GENERAL COMMENTS

Hibernia Drill Centres Construction and Operations Program Comments on Environmental Assessment Report

Figure 1. Years with large ice incursions into the study area are shown with arrows.

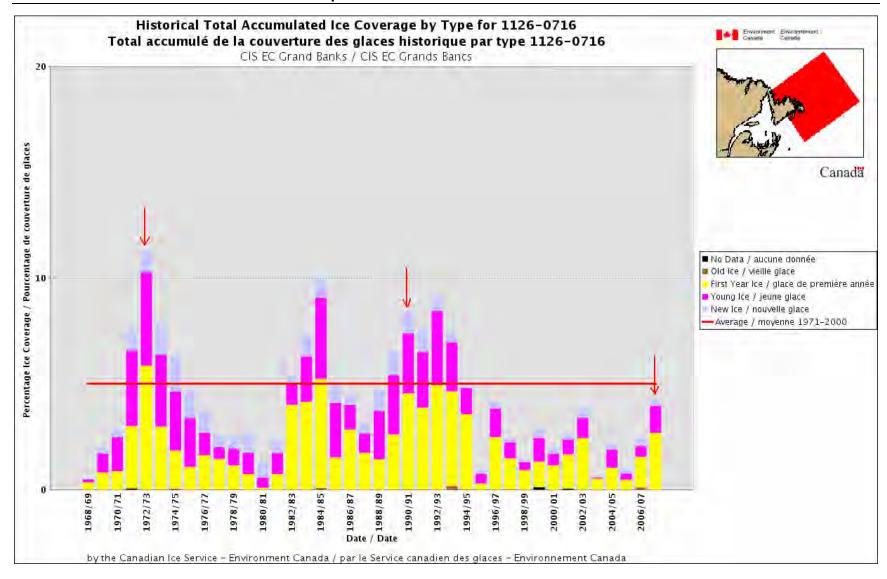
- S33. "Pack ice incursions into the ice monitoring zone around Hibernia have been recorded in two years (2003 and 2008) since the installation of the Platform (P. Rudkin, pers. comm.)." According to the CIS weekly ice charts, unusually large incursions occurred in 1973, 1990+1991, and 2008. These extreme events appear to be spaced roughly 18-19 years apart. Time series of Total Accumulated Ice Coverage (TAC) for the Grand Banks area (see Figure 1 Appendix A) show that the years with large incursions correlate with years of high average ice coverage in the region. Years with large TACs generally also have large iceberg numbers because sea ice protects icebergs from melt/erosion as they drift southwards. Also, the same winds/currents that drive the sea ice into the Grand Banks area also drive the icebergs into the GB area.

- S37. §3.3.2 Recent Past Ice Seasons, pg. 68 "The pack ice cover over the 2004/05 season was light, although not as light as the 2003/04 season (see Figure 1 Appendix A of these comments). The maximum southerly extent of the pack occurred on March 14th, which is typical of the maximum extent of pack ice over the past thirty years. The pack ice was 51 miles northwest of Hibernia and consisted of only 40 percent ice cover. The 2005 IIP iceberg season opened February 28th as the pack encroached on the top of the Banks and closed with the last iceberg being dropped from the tracking system 07 April 2005. Over those 38 days a total of 1 iceberg was tracked, its course did not require any management operations."

Figure 2. The Petermann ice island can be tracked using the sailwx.info ship tracker. The beacon # is 47557.

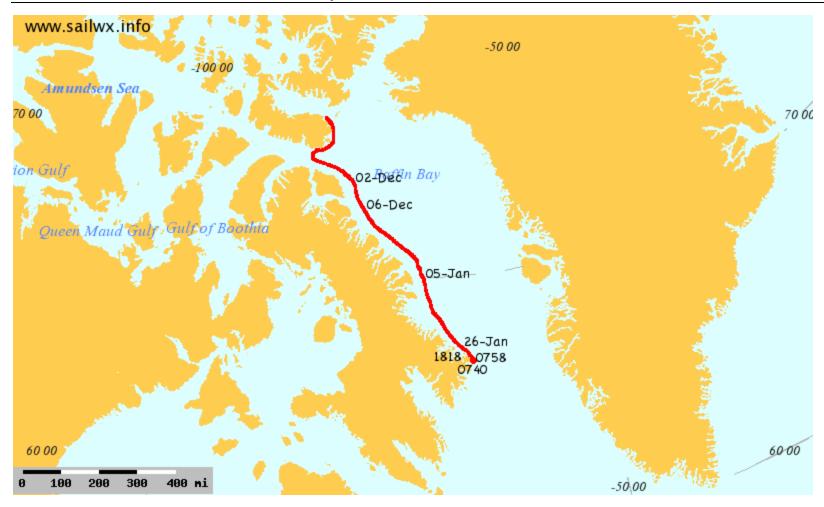
- S34. "Icebergs can have drafts larger than 150 m in off-shelf areas, but while in on-shelf areas, icebergs drafts are restricted to 20 to 100 m because of water depth. For water depths less than 100 m the mean iceberg mass was 125,000 tonnes (LGL 2008b). Iceberg drift speeds in the area show a correlation with sub-surface currents. Iceberg drift speeds measured from various drilling operations on the Grand Banks show speeds ranging from 0 to 1.3m/s, with a mean drift speed equal to 0.3 m/s (LGL 2008b)." Ice islands (very large, flat, tabular ice bergs) sometimes reach the Grand Banks. In summer 2008, such an ice island broke off the Petermann Glacier in northwest Greenland and drifted south into Baffin Bay, where it was tagged with a beacon. At the time it was tagged, it was ~8km long, 20 km², had a draft of 50-55m, and massed 1 billion tonnes. It passed Cape Dyer at the southern end of Baffin Island on January 29, 2009, at which time it measured 5km long and 13.75 km² (see Figure 2 Appendix A). This ice island may reach the Grand Banks in the summer 2009 season.
